Amendments to the NSCAS Description and Quantity Procedure

Draft Report – Standard consultation
for the National Electricity Market

Published: 18 September 2024

Figure 1 Number of remaining days requiring market intervention for system strength for financial year 2026

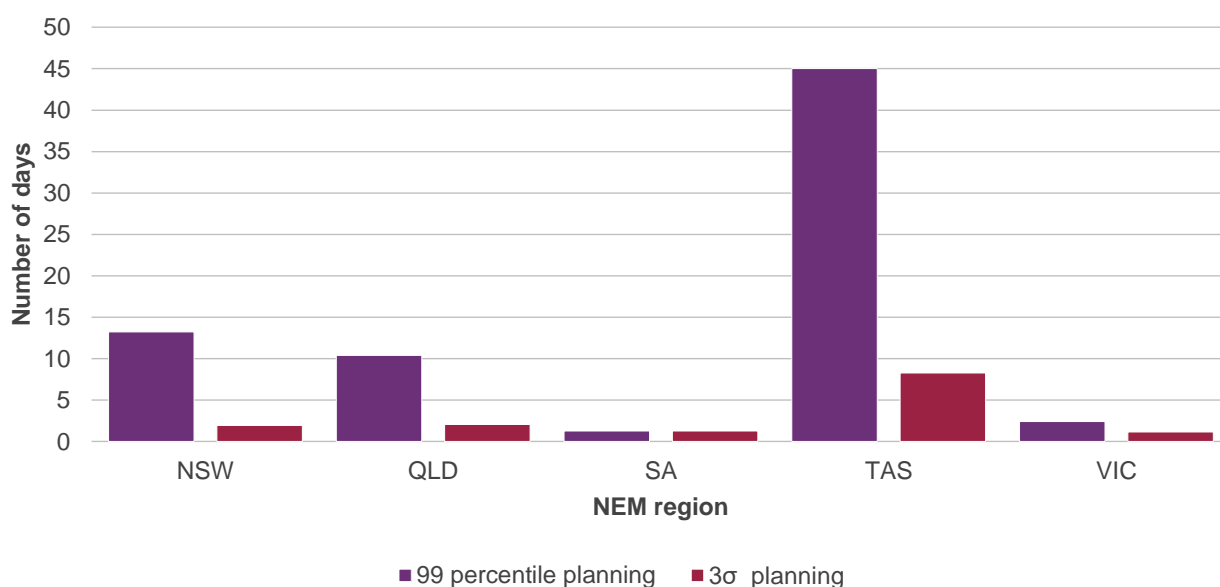
EUAA and Powerlink highlighted that this change presents a risk of over-procuring NSCAS, with associated potential for increased costs. Powerlink also noted the challenges with changing the existing measure (1% tolerance band), considering their obligations to provide system strength services, and respond to existing inertia shortfalls.

AEMO has analysed how many days would require market intervention when a 99th percentile is used, compared with a three standards deviations from the mean approach. Figure 1 below shows the number of days where AEMO's projection indicates directions for system strength

services would be required⁴, for each region. With a 99th percentile approach, over 72 days⁵ (across all regions) are projected to require market intervention due to insufficient levels of system strength economically dispatched, even with the system planned to meet the requirements for 99% of the time. This would reduce to less than 15 days when planning to meet the system strength requirements for 99.87% of the time.

AEMO understands the concern that increasing the statistical measure could lead to increased costs to consumers as a result of procuring more NSCAS. While this is a possible outcome, AEMO is also cognisant that failing to plan for greater uncertainty could have greater adverse consequences (and therefore costs) in terms of power system security and reliability issues. A shortfall in system strength or inertia network services in operational timeframes will lead to uncertain directions costs (assuming suitable plant is available for direction), and the potential for significant constraints and supply interruption.

For the reasons explained above, AEMO considers that a more conservative measure of uncertainty is warranted to identify inertia RSAS and system strength RSAS requirements.

AEMO will amend the Procedure to use a three-sigma from the mean statistical measure when determining NSCAS needs for inertia RSAS and system strength RSAS.
